**HOOPER CITY
CITY COUNCIL AGENDA
SEPTEMBER 15, 2022 7:00PM
COUNCIL CHAMBERS
5580 W. 4600 S.
Hooper, UT 84315**

Memo

To: Doug & JoAnne Higley and Alan & Valerie Staley
From: Hooper City Staff
CC: Mayor Fowers, Jared Hancock, Tracy Allen, Briant Jacobs
Date: August 8, 2022
Re: Higley Minor Subdivision Review

The Hooper City staff has completed its fifth minor subdivision review of the Higley Subdivision. The purpose of this subdivision is to create two buildable house lots on the west end of parcel 24-005-0030 on the corner of 5600 South and 6300 West. This property is zoned R2. New comments are in **purple**. Completed items have been shaded grey. **Response comments in green.**

PROJECT DATA FOR
HIGLEY SUBDIVISION

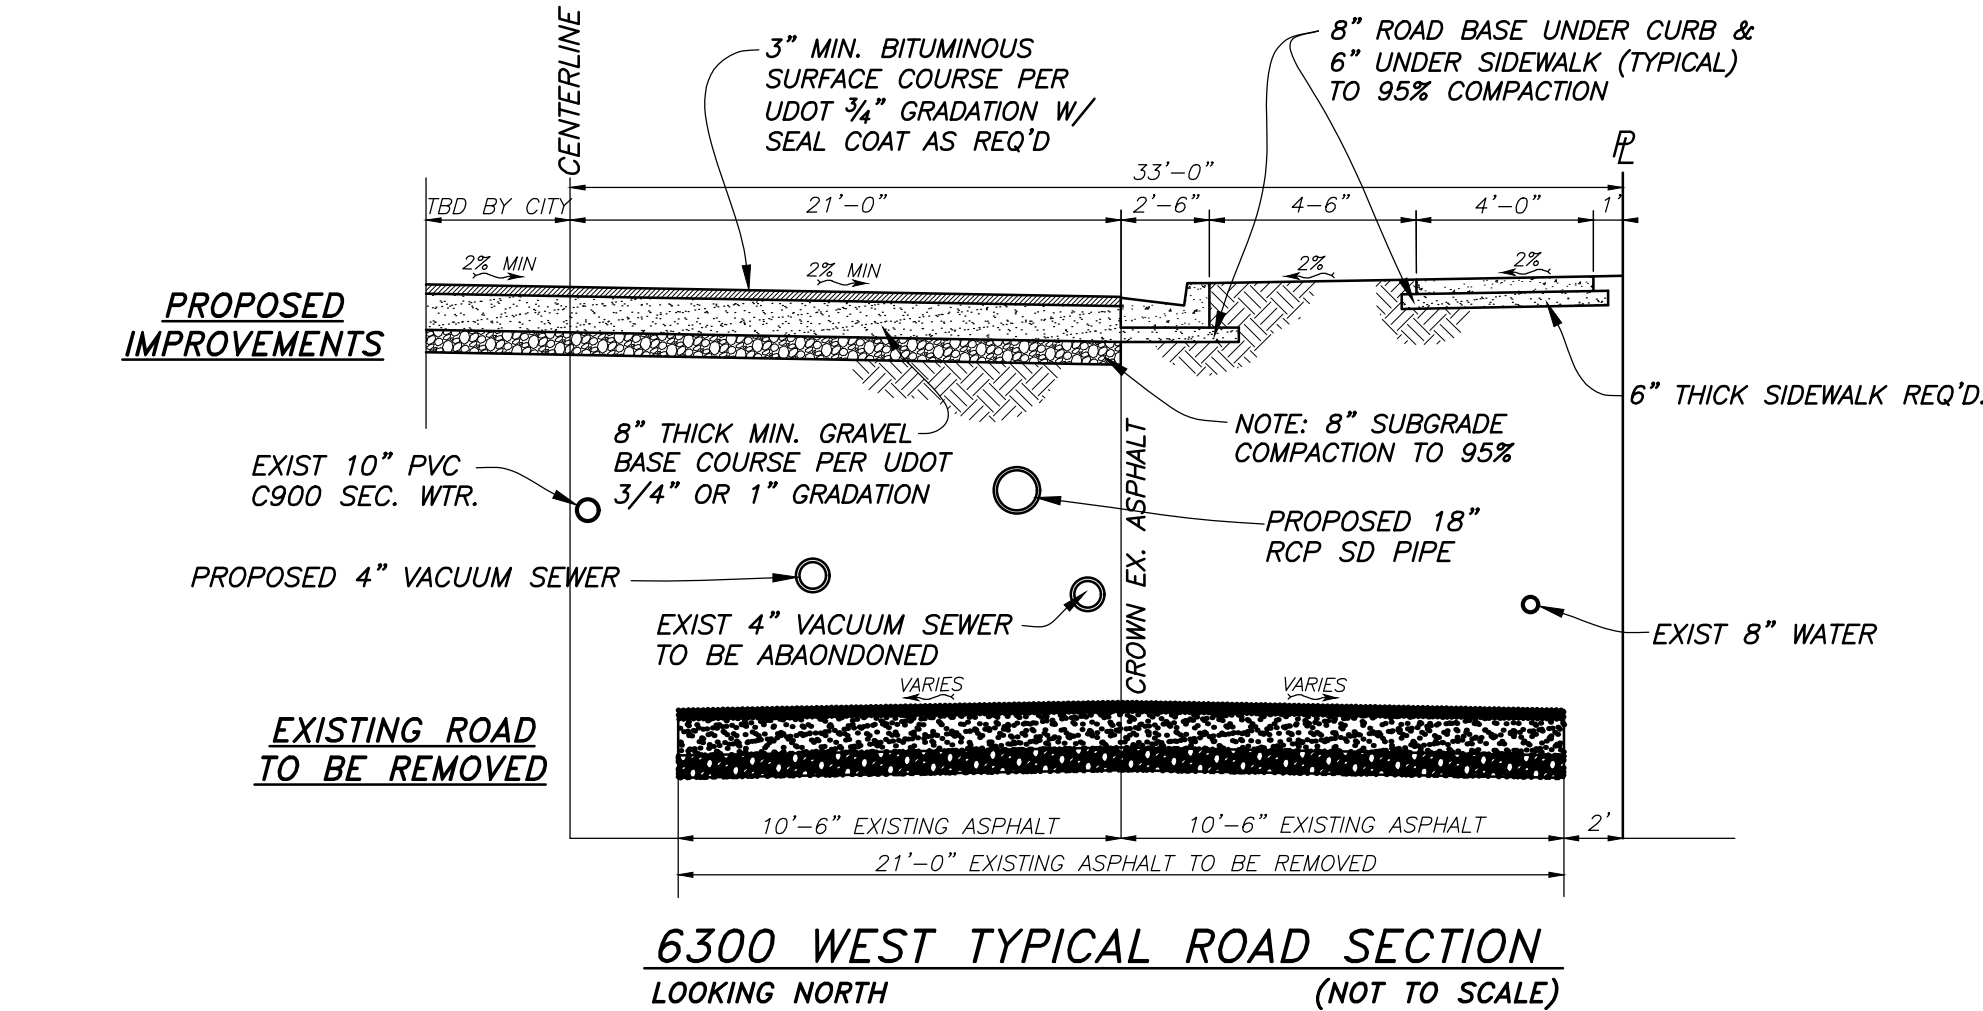
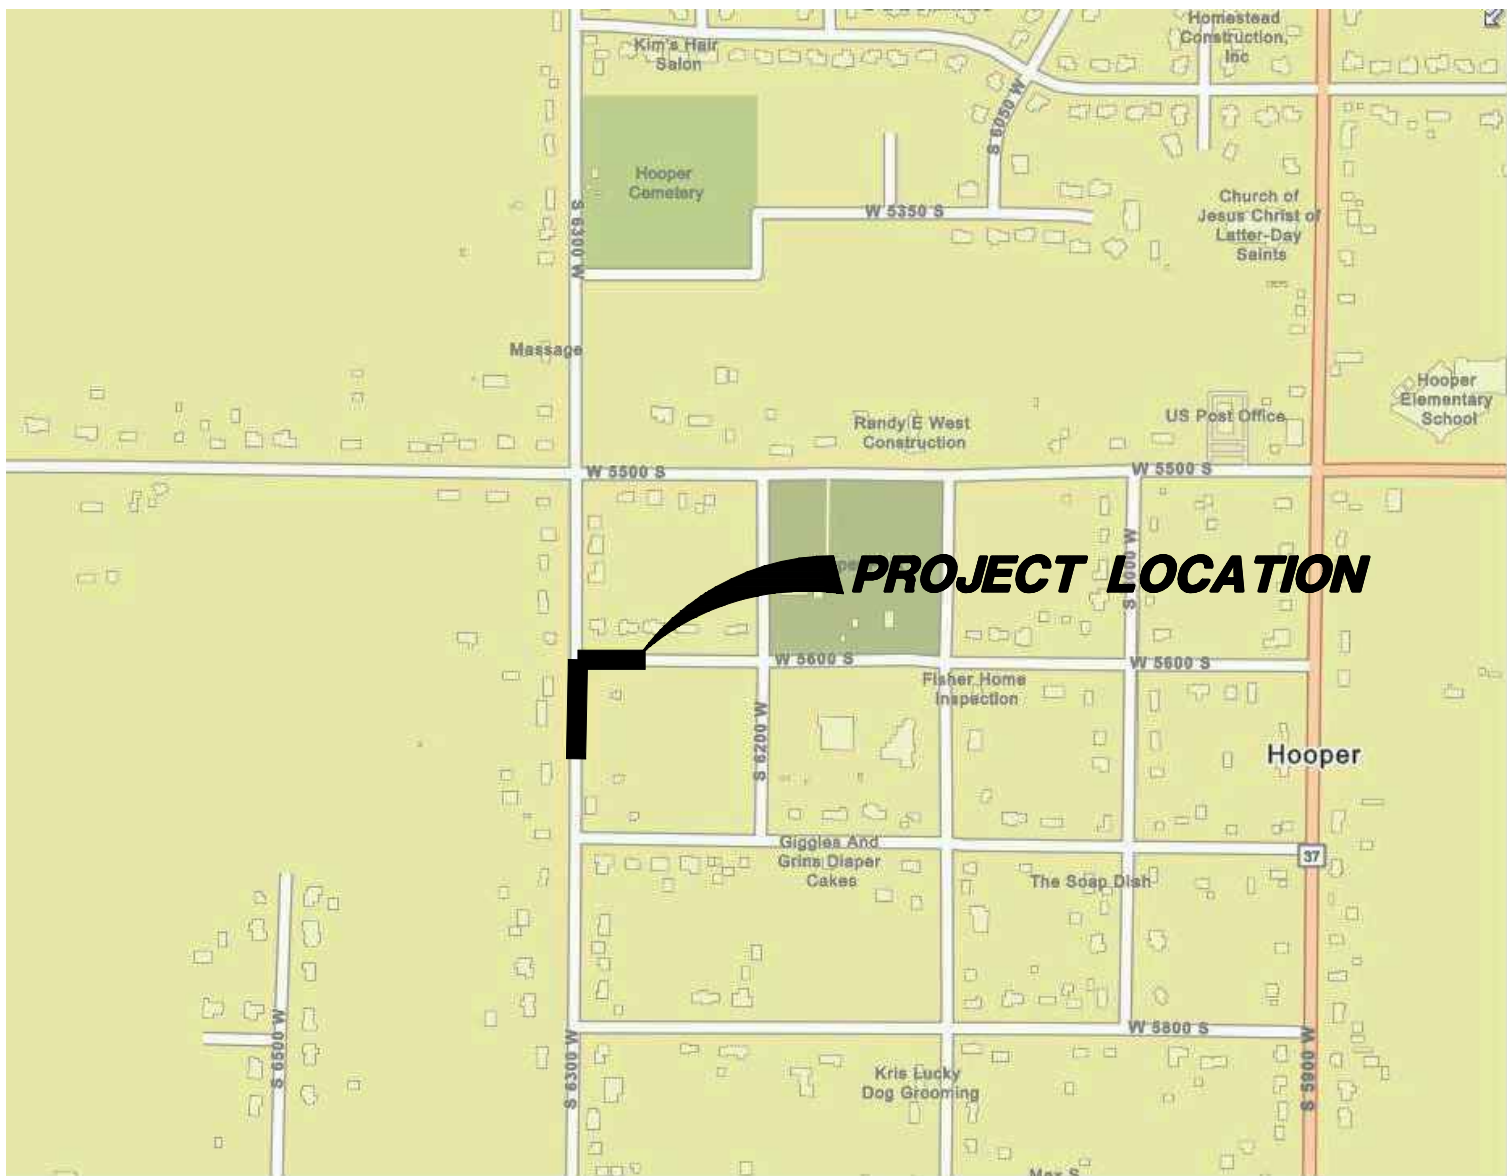
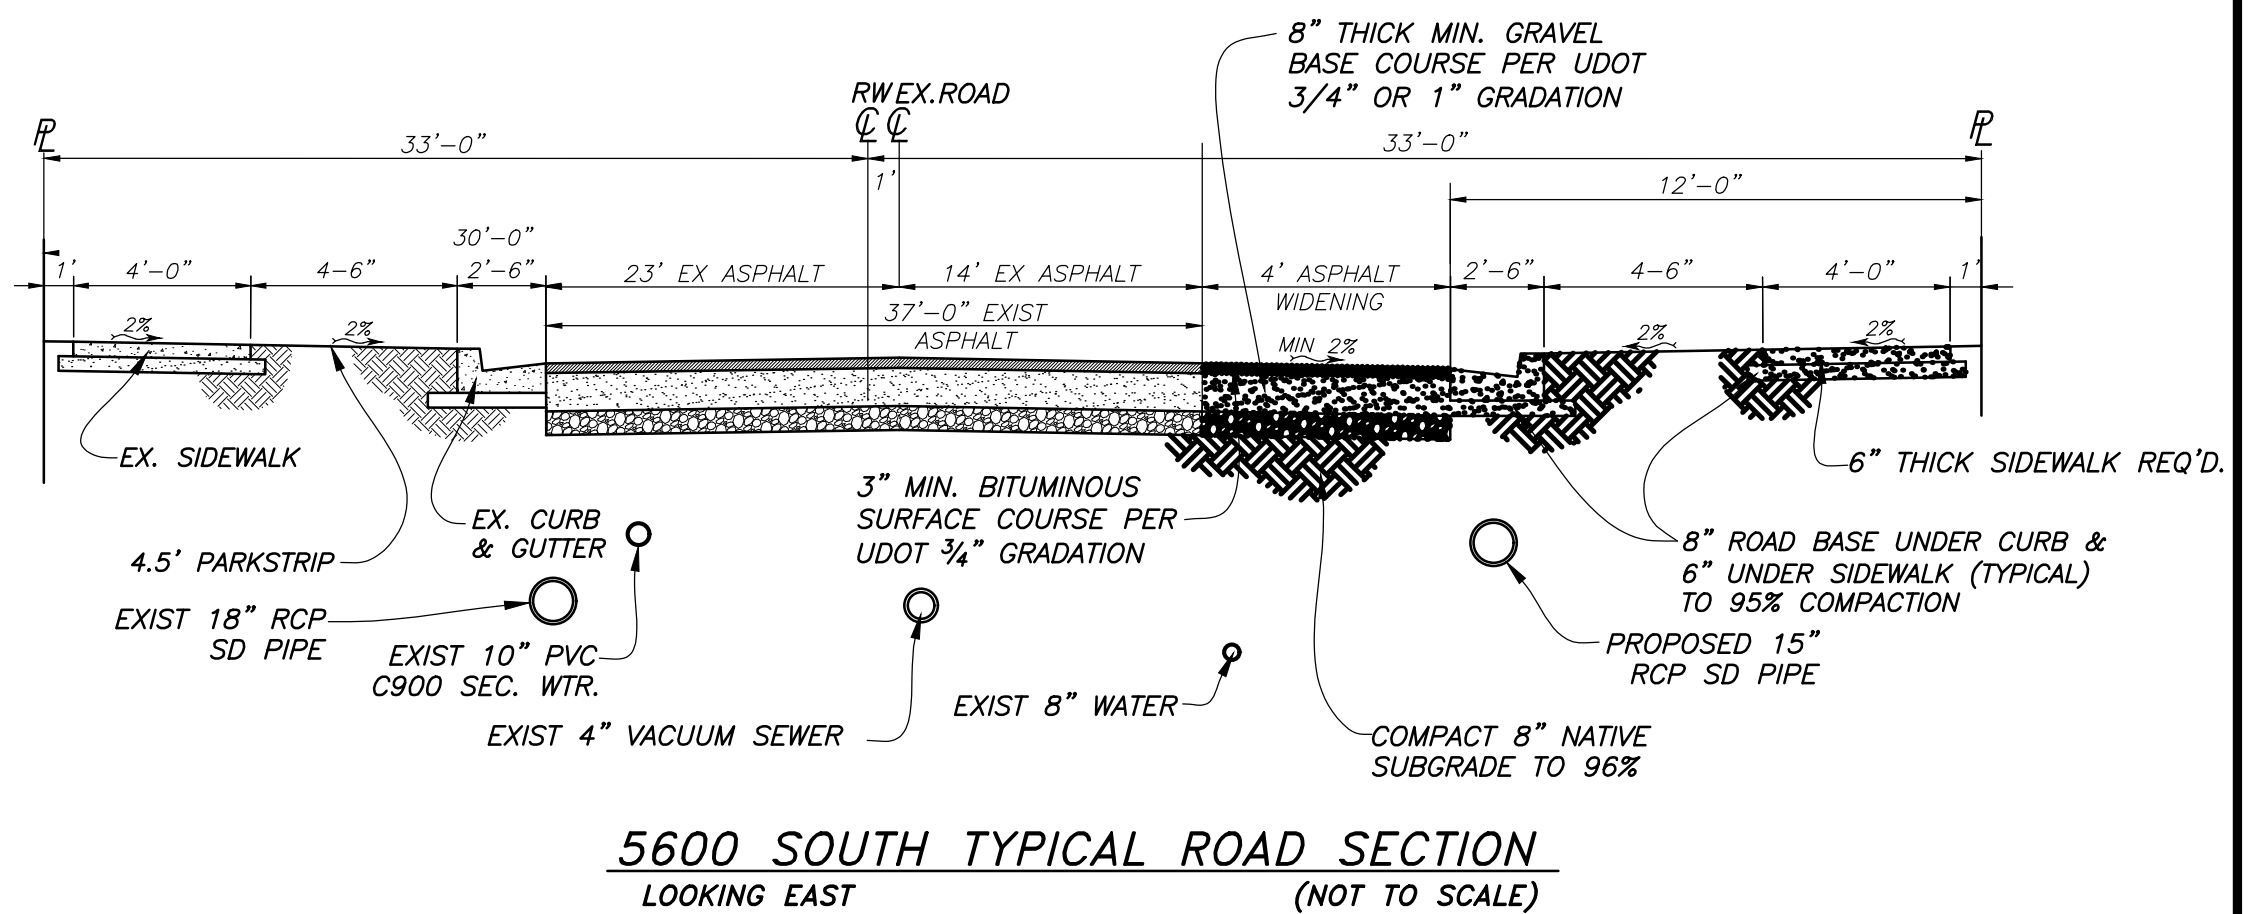
3. Per City Standards, the road base under curb and gutter should be 8-inch thick and 6-inches thick under the sidewalk. Please update both notes on Page 1. *Both notes have been updated on sheet 1.* **Okay**

4. On Page 1, on the 6300 West Typical Road Section, the 7'-0" left of centerline should be changed to read "DETERMINED BY CITY" and the 2% slope in the street should have "(MIN)" added. *The note has been changed to read "TBD BY CITY" & the "MIN" note has been added to the 2% cross slopes.* **Okay**

17. Road Section Details on Sheet 1 need to be corrected per City standards and to reflect what is existing. **Okay**
18. Storm drain calculations are needed for storm drain pipe flow and sizing for both the proposed pipe and the existing pipe. **Okay**
